HSS 6x6 1/2

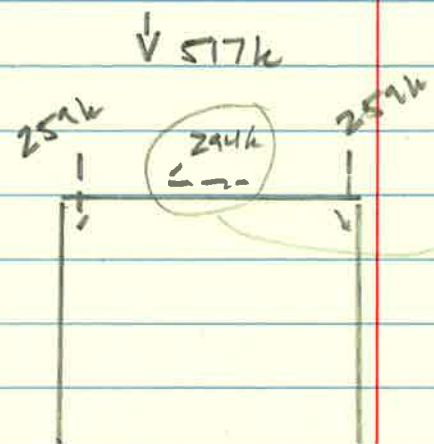
DOES OVERTURNING
FROM HORIZONTAL
COMPONENT GET
ADDED?
